PULSIPHER FARMS · LOGANDALE, NEVADA · CHRISTMAS TRAIN (PF-CT)

Powered truck + final drive / motor mounting (Ø1,450, MS05 + chain; detail L-103.2)

Sheet L-103 · REV L4.2 · 2026-10-28 · 1:25 at 17x11

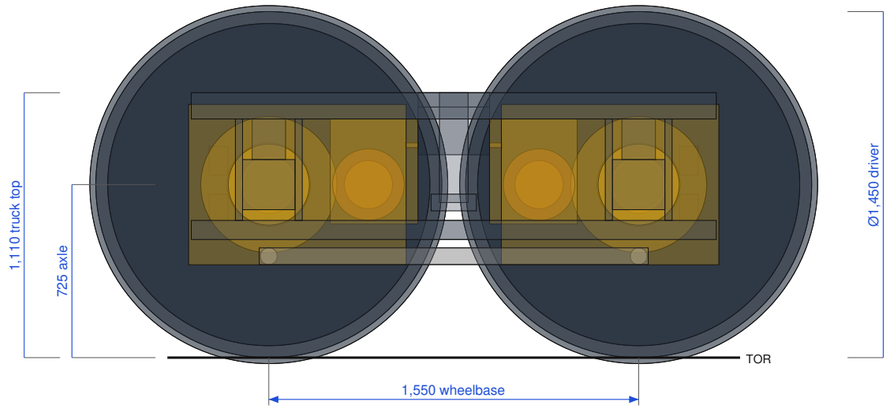
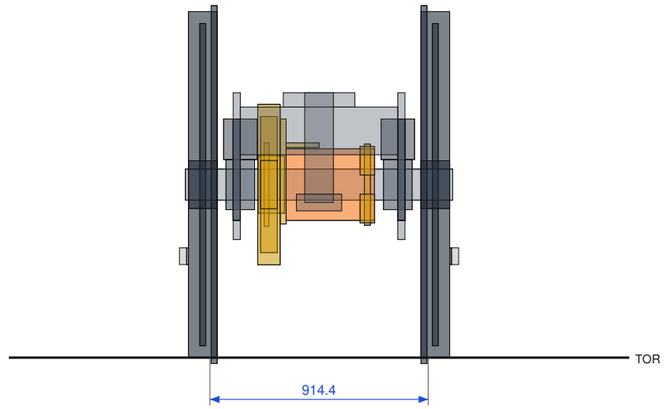
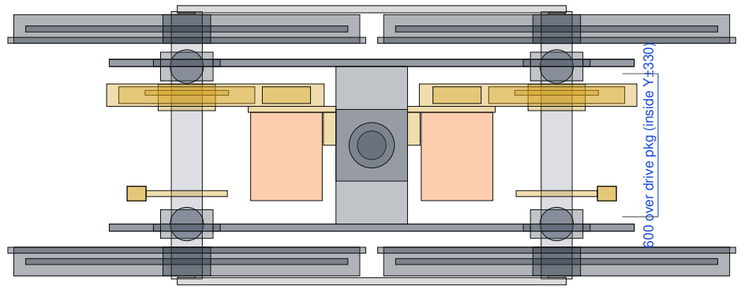
REV L1: plan LT18-LT20 truck - inside sideframes Y±330-360,
top Z1110; drivers Ø1,450 exposed outside; flange gap 50 in truck.
Transom PL16 box; pivot seat + Ø100 spherical pivot (LT20 GE100ES-2RS cand.).
REV L4 per axle (Y-): 45T 120-2 split rim ring bolted to a Ø150 pressed flanged hub
(no key, SHRINK 0.15-0.20), 54-link chain C417.6 to a 15T
on MS05 shaft code 5 W55x3x17; motor on PL25 slotted bracket under transom
(4x M20 10.9, 2 jack screws, 37 mm slide); oil-bath case Y-257..-163,
Z389-1061 (>=15 radial at 3% + travel), floating seal plate. Clear: case 3 / hub 5 to
spring reservation, motor 57 (23 at 3% stretch) to transom.
Disc Ø340x25 on axle Y+ + 2 spring calipers (B1-g), unchanged.
Removed: Dodge TA7315H15MS, H1B110, belt drop, TA rod.
AWAIT: Poclain AE (radial/offset, spline); chain/sprocket maker.
Inside axleboxes AWAIT bearing; primary springs AWAIT (LT35).
Anti-slip (L4.1): NO flow divider - PLUS+1 traction control, pony 3rd pickup, sand.

L4.2: LOW TRACTION PIN Ø120 4140 + GE120ES housing under transom at Z650
(X4075/7275, calc L42-tp); centre plate flat-lined (vertical only). Bump stops ±22.
L4.2: sanders on BOTH trucks (level + flow proof, hill-hold); flange withdraw 28,
re-profile <= 27 (all wheels); P-103-1 hanger L-weld + 2 PL16 gussets (Loco Bot L-103).
